JAFP-17-0116
RS-17-151

James A. FitzPatrick Nuclear Power Plant
Renewed Facility Operating License No. DPR-59
NRC Docket No. 50-333

Subject: Seventh Six-Month Status Report For Phases 1 and 2 Overall Integrated Plan in Response to June 6, 2013 Commission Order Modifying Licenses with Regard to Reliable Hardened Containment Vents Capable of Operation Under Severe Accident Conditions (Order Number EA-13-109)

**Seventh Six-Month Status Report for Phases 1 and 2 Implementation of Order EA-13-109,
Order Modifying Licenses with Regard to Reliable Hardened Containment Vents Capable
of Operation Under Severe Accident Conditions**

Phase 2 Overall Integrated Plan: Sketch 1

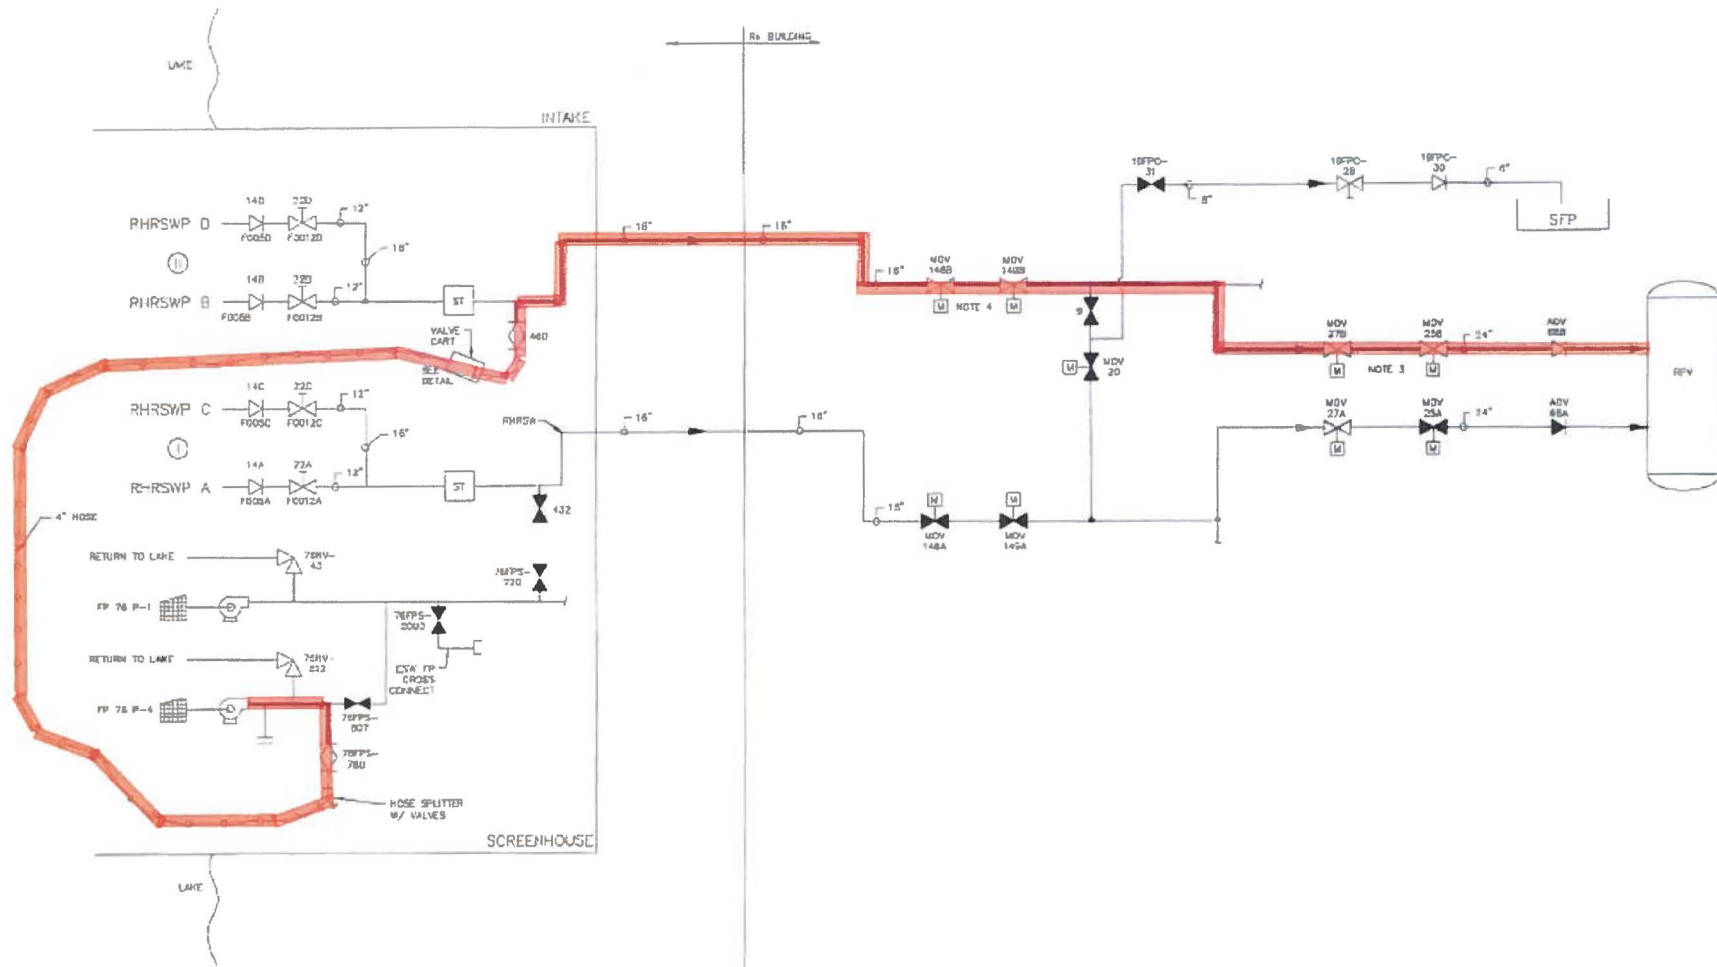
Severe Accident Operation, Table 3.1.B, Greater than 24 Hour Coping Detail; Attachment 1; Attachment 3 Sketch 1, 3 & 4 (A/B)

The SAWA injection pathway has been updated to use the RHR 'B' train rather than the RHR 'A' train as reflected in the Phase 2 OIP (Sketch 1 is updated below to reflect this change). This update, resulting from the final detailed design, yields a strategy with less operator actions. A new common FLEX/SAWA cart mounted throttling valve and flow meter will be installed between valves 10RHR-460 and 76FPS-780. This throttling valve will be used to adjust flow rate, as needed. Resulting from this change, the credited ECCS check valve is 10AOV-68B. The following valves require modulation:

- 10MOV-148B (Manual Open)
- 10MOV-149B (Manual Open)
- 10MOV-25B (LPCI Batteries)
- 76FPS-807 (Manual Close)
- 76FPS-780 (Manual Open)
- 10RHR-460 (Manual Open)

It is noted that 10MOV-27B is normally open and 10RHR-11B no longer requires closing as it is a system dead leg.
